Access Compliance Report

Public Rights-of-Way

Intersection ID: 13598	Main Street: W_KINGSTON_AV	Cross Street: WICKFORD_PL	Location: S
ADA ID: E55CB0A3AFBF	Ramp Type: PerpDiag	Initial Pass/Fail: Fail	Overall Compliance: No
		Severity Score: 1.25

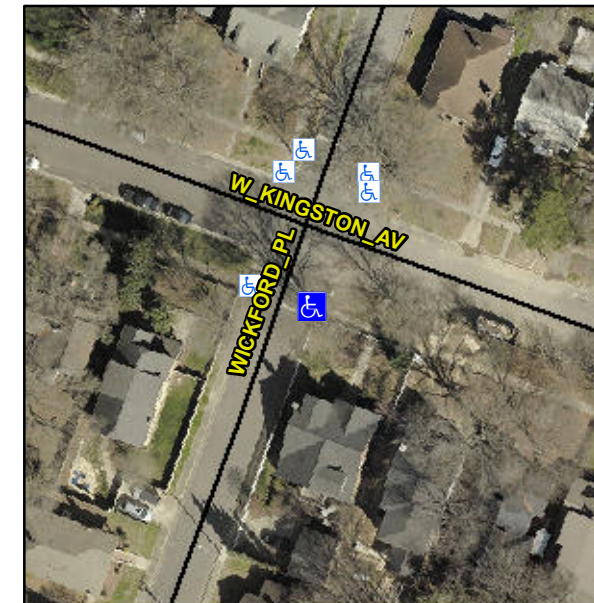
Not Found, R304.5.3

Compliance	Description	Data	Compliance	Description	Data
N/A	Ramp Length (in)	48.0	Yes	Ramp Slope (%)	6.6
Yes	Ramp Width (in)	80.0	No	Ramp XSlope (%)	2.7
N/A	Flare Type LT	N/A	N/A	Flare Type RT	N/A
N/A	Flare Slope LT (%)	N/A	N/A	Flare Slope RT (%)	N/A
N/A	Flare Traversable LT?	N/A	N/A	Flare Traversable RT?	N/A
N/A	Landing Length (in)	N/A	N/A	DWS Provided?	N/A
N/A	Landing Width (in)	N/A	N/A	DWS Contrast?	N/A
N/A	Landing Slope (%)	N/A	N/A	DWS Length (in)	N/A
N/A	Landing X Slope (%)	N/A	N/A	DWS Full Width?	N/A
N/A	Landing Curb? (Y/N)	N/A	N/A	DWS Offset (in)	N/A
N/A	Shared Landing?	N/A			
N/A	Gutter Ponding?	N/A	N/A	Gutter Slope (%)	N/A
N/A	Gutter Lip Ht (in)	N/A	N/A	Gutter X Slope (%)	N/A
N/A	Painted X Walk1?	No	N/A	Painted X Walk2?	No
	X Walk 1 Direction	To NE		X Walk 2 Direction	To NW
N/A	X Walk 1 Width (in)	N/A	N/A	X Walk 2 Width (in)	N/A
	X Walk 1 Slope (%)	0.2		X Walk 2 Slope (%)	1.2
	X Walk 1 X Slope (%)	0.6		X Walk 2 X Slope (%)	2.0

Remove & Replace Curb Ramp With Two New Directional Ramps or Equivalent.
